PROPOSED GREYSTONE COUNTRY ESTATES

PRELIMINARY OVERALL AREA DEVELOPMENT PLAN APPLICATION (POADP)

POADP # 541

The City Staff Development Review Committee has reviewed Fund Subdivision Preliminary Overall Area Development Plan # 541. Please find enclosed a signed copy for your files. Although your plan was accepted, please note the following:

BROWN ENGINEERING CO.		REVISIONS	
ENGINEERING CONSULTANTS SAN ANTONIO, TEXAS 78209 PHONE (512) 484-8511		No.	Date
JOB NO. 227-001-00 DATE 09/08/94		App.	
RIVER CITY ASSOCIATES L.L.C. FUND SUBDIVISION		SHEET NO. 1	
P.O.A.D.P.		Date: 26 Nov 1996

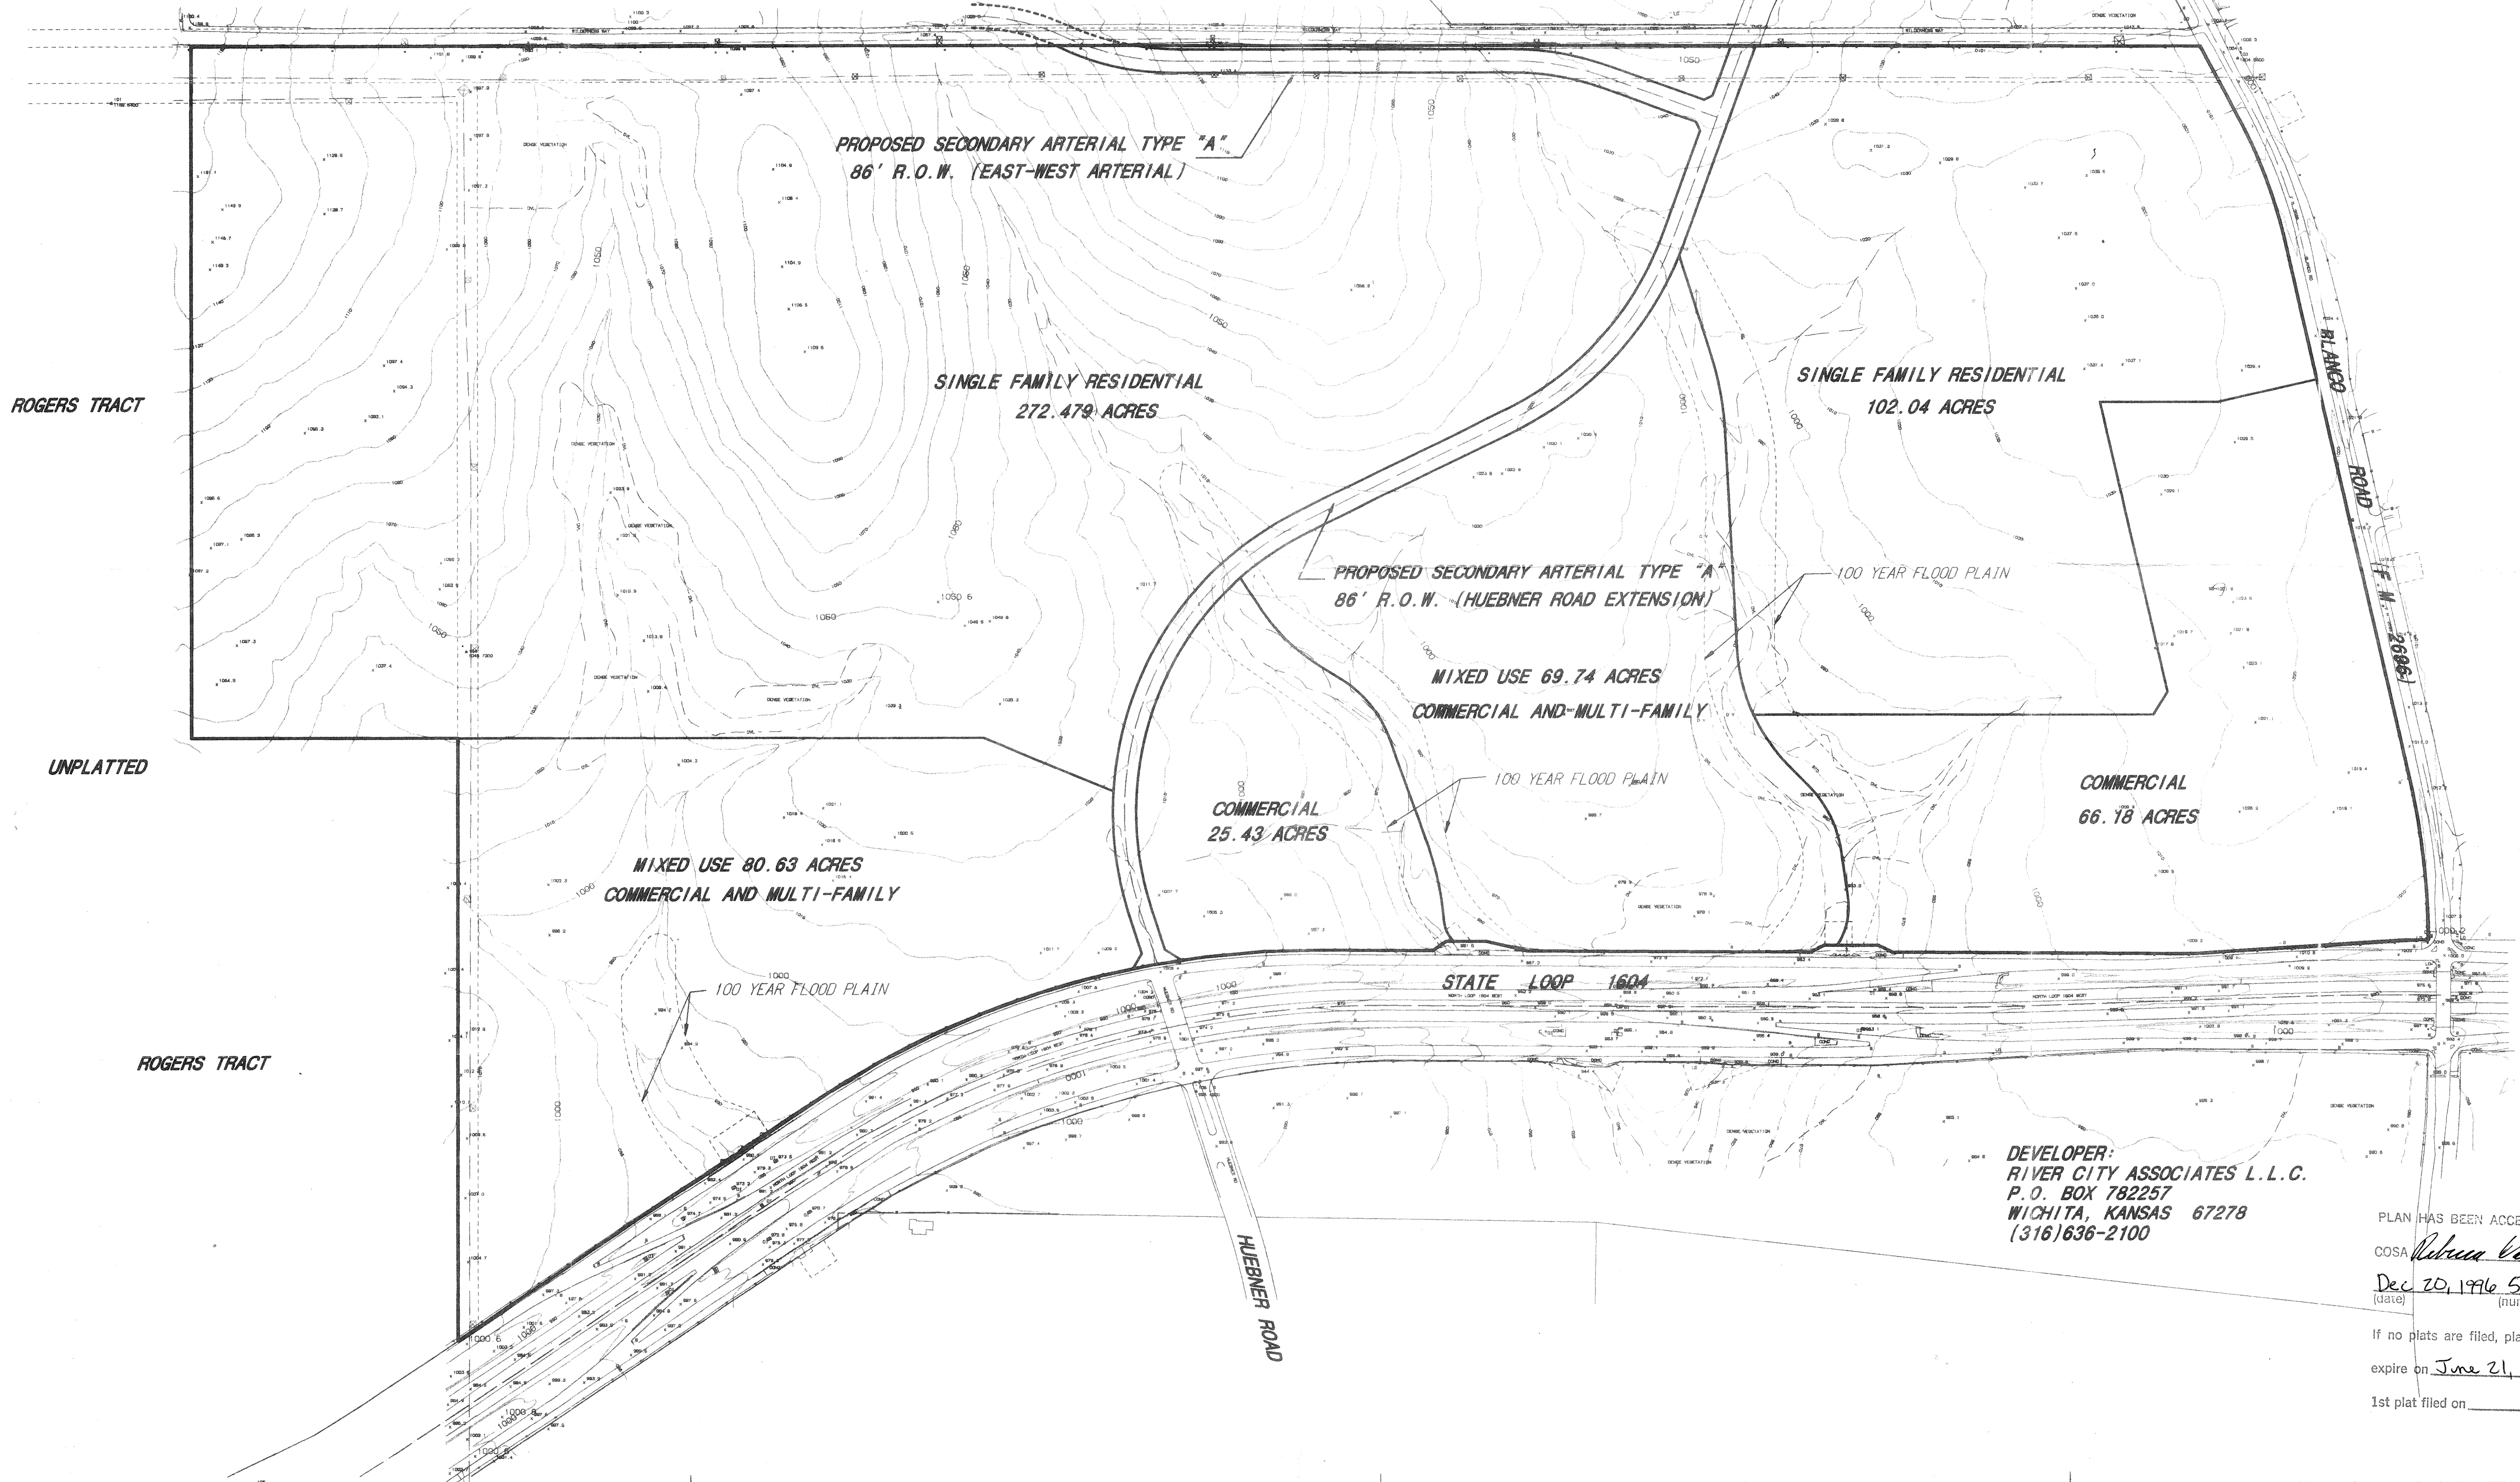
- Access issues along State facilities will need to be resolved with the Texas Department of Transportation (TXDOT). For additional information about these requirements you can contact TXDOT at 615-5814.
- Based on the topography, a Flood Plain Study and drainage review will probably be required during the platting process.
- This development will probably need to conform to requirements associated with development over the Edwards Aquifer. For additional information about these requirements you can contact SAWS at 704-7305.

Comments: FLOOD PLAIN DEVELOPMENT PERMIT AND DRAINAGE
EASEMENTS WILL BE REQUIRE AND ADDRESS DURING
THE PLATTING PROCESS

Elizabeth,
We need to get the geometry revised as shown
in order to release two(2) platting units
(4A & 5A). We will also be revising ownership
information at a later date. Thanks
